LOT 105			
LOT No.	LOT WIDTH (M) (± 0.0m)	LOT AREA (M ²)	344
105	12.50	344

Greenpark
RUSSELL GARDENS PHASE 2
HAMILTON

Project No. 16036
Reference plan No. 105
Drawing No. 1

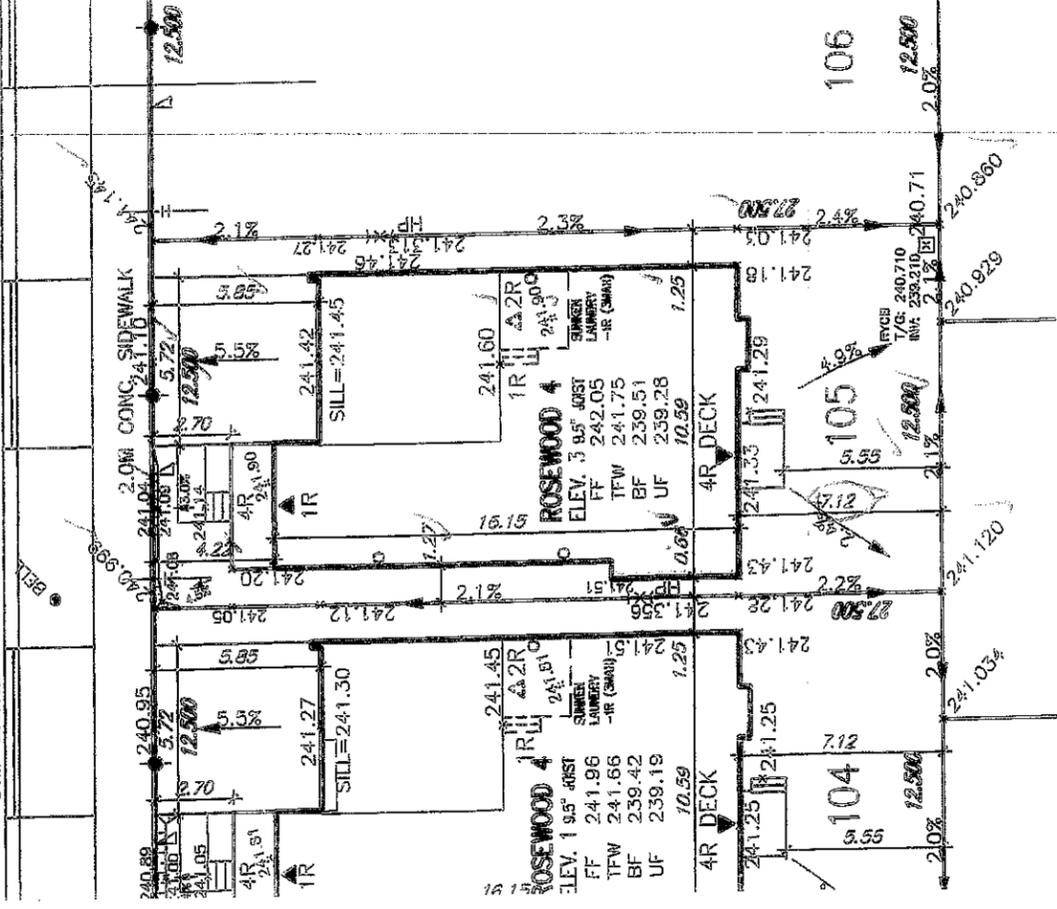
THIS LOT GRADING PLAN HAS BEEN REVIEWED BY METROPOLITAN CONSULTING INC. FOR CONFORMANCE WITH THE APPLICABLE SUBDIVISION GRADING DESIGN. THE PROPOSED GRADIES ON THIS PLAN ARE IN GENERAL CONFORMANCE WITH THE APPLICABLE GRADING PLAN AS RELATES TO THE LOT AND ADJACENT LOTS. WHERE THE BASEMENT FLOOR OR OTHER FOUNDATION ELEVATIONS ARE PROPOSED AT A DIFFERENT ELEVATION THAN THAT SHOWN ON THE APPROVED SUBDIVISION PLANS THE DESIGNER SHALL SHOW ON THE APPROVED SUBDIVISION PLANS THE SAME MATERIALS HAVE BEEN REVIEWED AND WE ARE SATISFIED THAT THE ACCORDANCE WITH THE REQUIREMENTS OF THE O.R.C. AND CITY DESIGN CRITERIA. NOTE: THIS SUBDIVISION DOES NOT REPLACE THE DESIGNER'S RESPONSIBILITY TO ENSURE THAT THE SEWER, WATER AND GAS LINES ARE PROPERLY LOCATED PRIOR TO CONSTRUCTION. THE SUBDIVISION DESIGNER IS RESPONSIBLE FOR THE SEWER, WATER AND GAS LINES. THE DESIGNER SHALL BE RESPONSIBLE FOR IDENTIFYING ANY VARIATIONS BETWEEN THE LATERAL INFORMATION AND GRADIES DEPICTED ON THIS PLAN AND THE COMPARISONS FOUND IN THE FIELD.
